Project **Plender Street
Camden**

Title **Building B
Section B1**

Drawing Number	Rev
A-B901	G

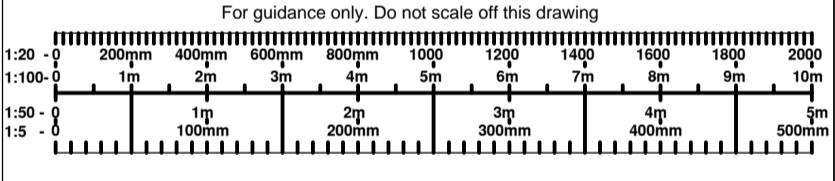
G	Brown roof construction incorporated	19.03.2015	KDR
F	External wall partition thickness reduced from 150mm to 100mm to Higgins instruction	16.12.2014	KDR
E	Concrete roof deck re-drawn as laid to falls, falls to suit structural engineer's design, cut to falls insulation replaced with single thickness, roof ballast reduced to 50mm, external partition wall studs reduced from 150mm to 50mm, all to Higgins instruction	24.11.14	KDR
D	Roof construction amended to client instruction, green roof omitted, photovoltaic panels incorporated to sub contractor detail	10.11.2014	KDR
C	Dimensions added	21.08.2014	KDR
B	Detail references added, notes added, status changed to Construction.	18.07.2014	KDR
A	Floor to floor heights increased to accommodate increased floor slab thickness as directed by structural engineer.	11.10.2014	KDR
Rev	Description	Date	Initial Checked
